UNITED STATES
DEPARTMENT OF THE INTERIOR
BUREAU OF LAND MANAGEMENT

SUNDRY NOTICES AND REPORTS ON WELLS
Do not use this form for proposals to drill or to re-enter an abandoned well. Use form 3160-3 (APD) for such proposals.

8. Well Name and No.
SALADO DRAW 29 26 33 FED COM 8H

Summary of Changes to APD Submission

See attachment. (1 page)

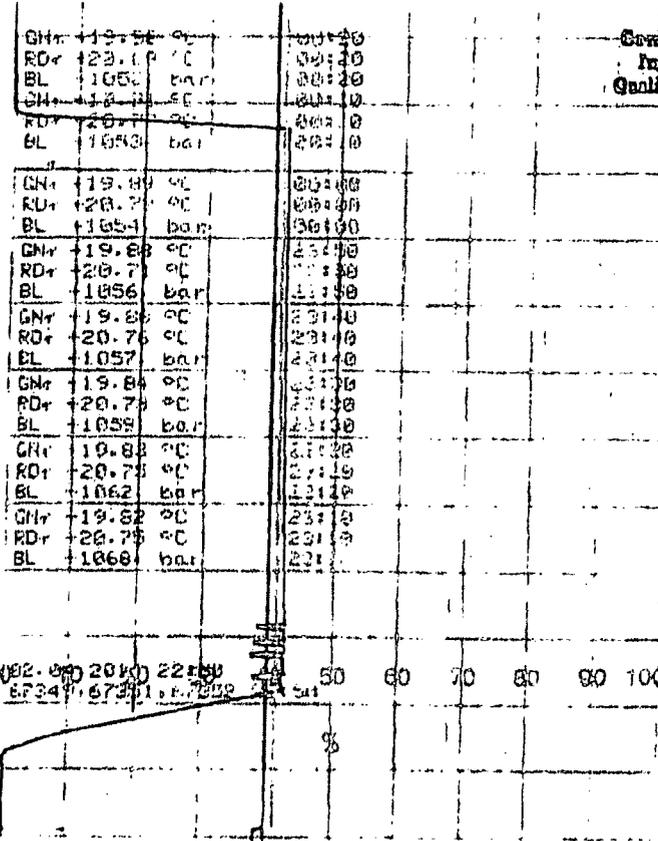
Chevron requests a variance to use a CoFlex hose with a metal protective covering that will be utilized between the BOP and Choke manifold. Please refer to the attached testing and specification documents.

Variance approved to use flex line from BOP to choke manifold. Check condition of flexible line from BOP to choke manifold, replace if exterior is damaged or if line fails test. Line to be as straight as possible with no hard bends and is to be anchored according to Manufacturer's requirements. The flexible hose can be exchanged with a hose of equal size and equal or greater pressure rating. **Anchor requirements, specification sheet and hydrostatic pressure test certification matching the hose in service, to be onsite for review.** If the BLM inspector questions the straightness of the hose, a BLM engineer will be contacted and will review in the field or via picture supplied by inspector to determine if changes are required (operator shall expect delays if this occurs).
